SYDNEY INTERNATIONAL CONVENTION, EXHIBITION & ENTERTAINMENT PRECINCT (SICEEP)

**Concept Proposals
SSD 5752-2012 & SSD 5878-2013**

Submission to the NSW Department of Planning & Infrastructure

10 May 2013

Figure 10. Diagram of Public Realm principles prepared as part of the SICEEP bid process April 2012. (Source: Woods Bagot, Urban Design & Public Realm Guidelines 2012, p.25)

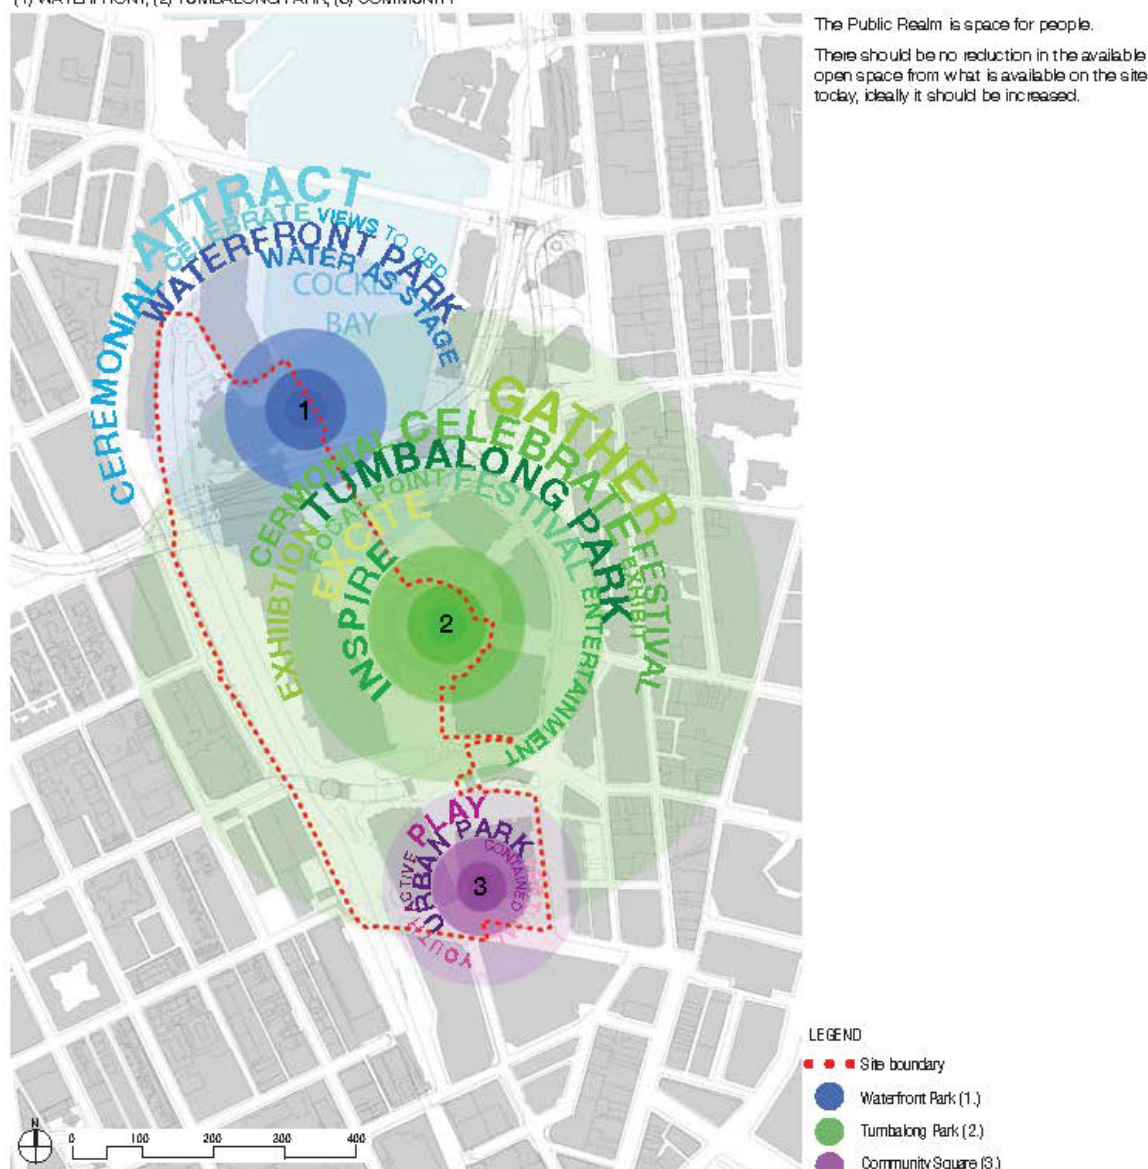
- 2.5.8 The Urban Design & Public Realm Guidelines prepared for the SICEEP bid process by Woods Bagot in April 2012 contain confused directions and contradictions that have clearly led to this inadequate outcome for the Haymarket Precinct.
- 2.5.9 As shown in Figure 10, the open space concept for the Haymarket Precinct was presented as an 'Urban Park', separate from the open space resources of Tumbalong Park and the Darling Harbour waterfront to the north. The Urban Park was branded with the following mix of verbs, nouns and adjectives: 'play', 'youth', 'active', 'contained', and separately identified in the Legend as a 'Community Square'.

- 2.5.10 At the same time, the Woods Bagot guidelines stated, 'There should be no reduction in the available open space from what is available on the site today; ideally it should be increased.'

- 2.5.10 Yet the proposal to separate and contain the Urban Park/Community Square as an internalised pocket in the Haymarket Precinct would entail large-scale redevelopment on a site currently occupied by two structures and an extensive plaza, leading inevitably to a reduction in open space 'from what is available on the site today.'

- 2.5.14 The public open space of the Haymarket Precinct should be (1) increased in size to meet the needs of a densely populated inner city neighbourhood in accordance with the 25 – 30% standard prescribed in the NSW *Residential Flat Design Code*, and (2) protected by sun access planes to prevent overshadowing in winter
- 2.5.15 In addition, the public open space of the Haymarket Precinct should be integrated with the green network of Darling Harbour and the ‘Liveable Green’ network of the City of Sydney. The squares and vest pocket parks of the Haymarket Precinct should be opened to the north in accordance with the 2010 JPW Urban Design Guidelines – not the 2012 Woods Bagot Guidelines - to ‘borrow’ space from Tumbalong Park and the Darling Harbour waterfront, both visually and functionally.

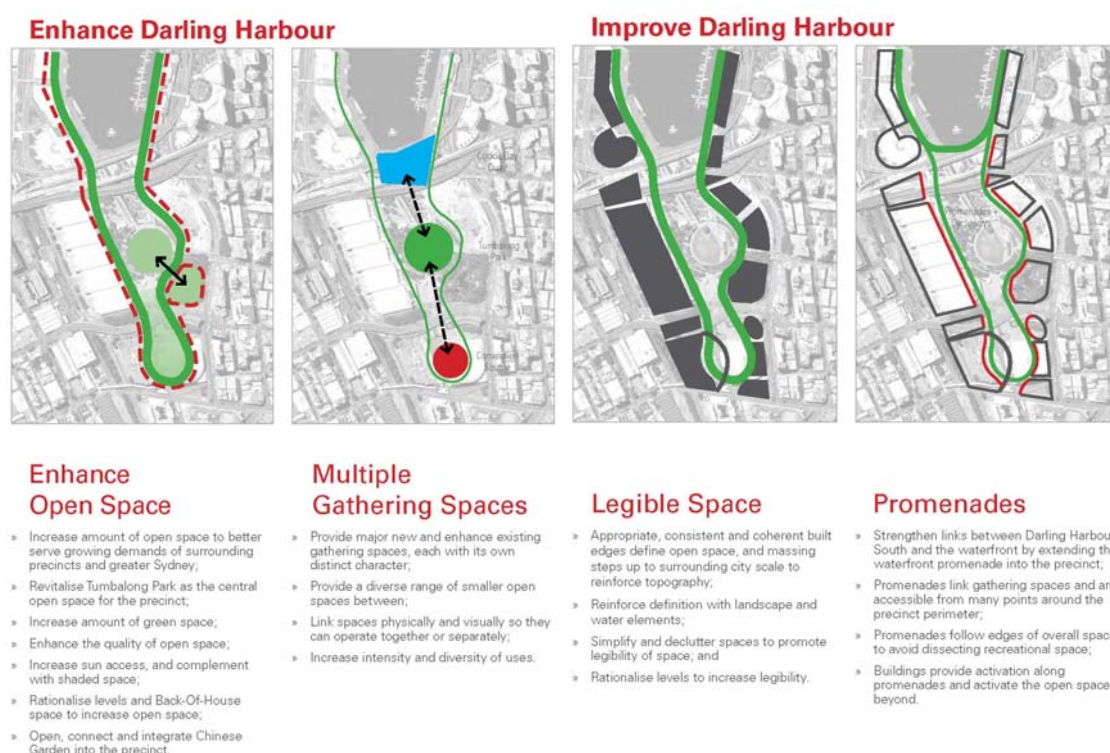
- 2.5.12 The scheme is misconceived and a blatant over-development of the site,
- 2.5.13 A sound basis for the revitalisation of Darling Harbour South was presented in a 2010 Urban Design Report prepared by Johnson Pilton Walker for the Sydney Harbour Foreshore Authority (Figure 11).

Figure 12. Sectional elevation of the SICEEP Haymarket scheme prepared by Denton Corker Marshall. (Source: JBA Planning SSD 5878-2013 EIS, Appendix J)

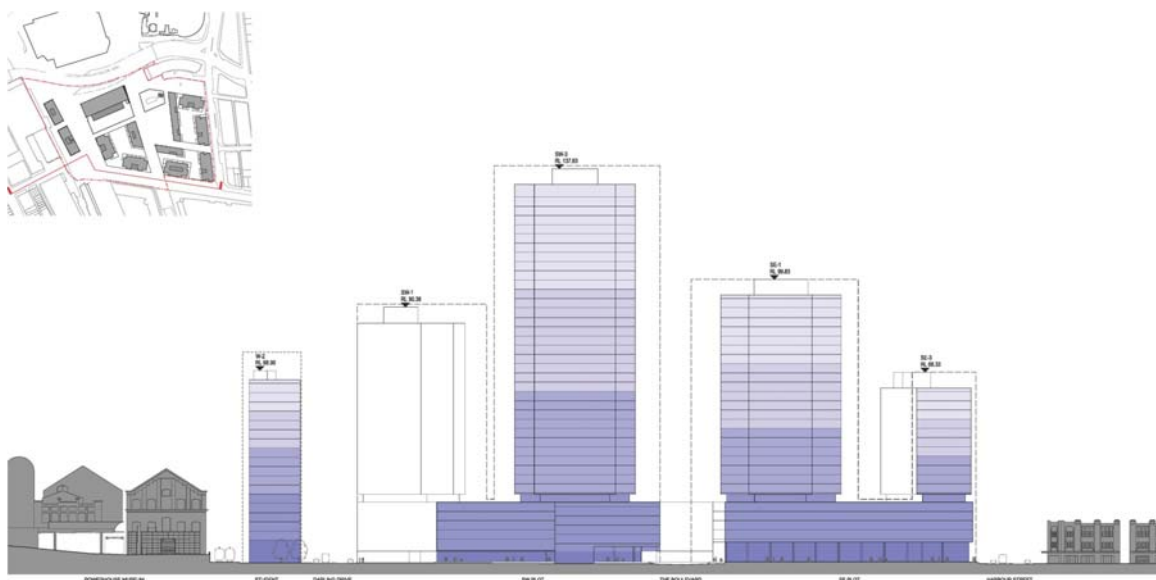
- 2.6.1 As stated in Section 1.3 (above) relocation of the Sydney Exhibition Centre to the Glebe Island Expo site as a permanent facility would permit the western side of Darling Harbour to be redeveloped as a series of world class convention and entertainment facilities integrated with residential and retail uses as part of a new, mixed-use urban precinct.
- 2.6.2 Relocation of residential development parcels from the Haymarket Precinct to the western side of Darling Harbour as part of this strategy would reduce over-development in the SICEEP Haymarket scheme and significantly improve its character, amenity and civic quality.
- 2.6.3 The scale of the SICEEP Haymarket scheme in relation to existing development in Ultimo and Chinatown is shown in the following sectional elevation (Figure 12).

Figure 13. SICEEP Haymarket scheme massing diagram prepared by Denton Corker Marshall. (Source: JBA Planning SSD 5878-2013 EIS, Appendix J, p.50)

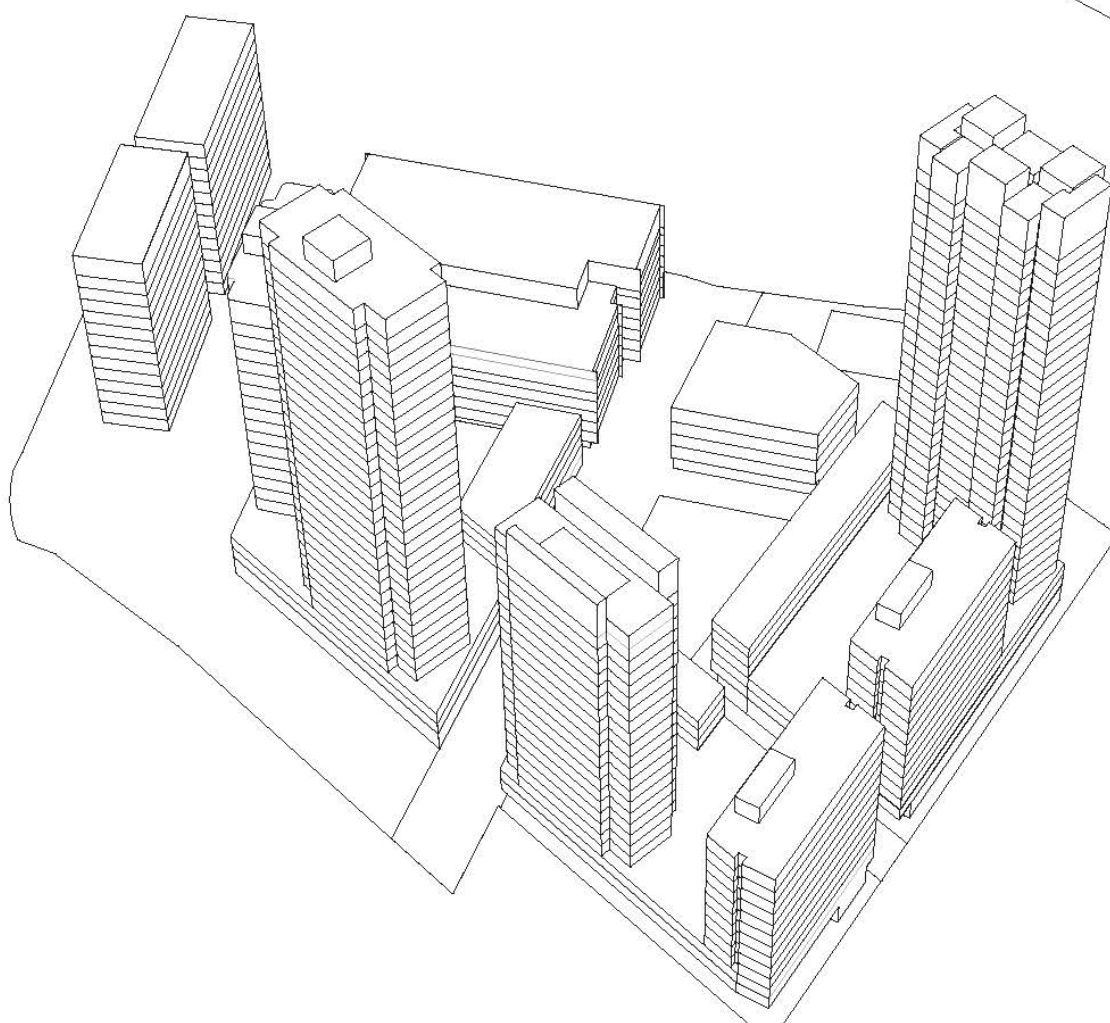
2.6.4 The massing diagram of the SICEEP Haymarket Scheme shows the configuration of the 16 buildings on the site, comprising 3 full-block podiums, 9 towers and 4 stand-alone buildings (Figure 13)

2.6.5 The scheme needs to be reduced along the following lines:

- removal of the twin 21-storey western blocks to create a civic square on the Darling Harbour frontage of the Powerhouse Museum;
- removal of the 6-storey block on the northern side of Haymarket Square to reduce overshadowing and open the Communal Open Space to Tumbalong Park;

- reduction in the height and bulk of remaining towers through the operation of sun access plane controls to provide winter sun access at street level for an expanded network of Communal Open Space.
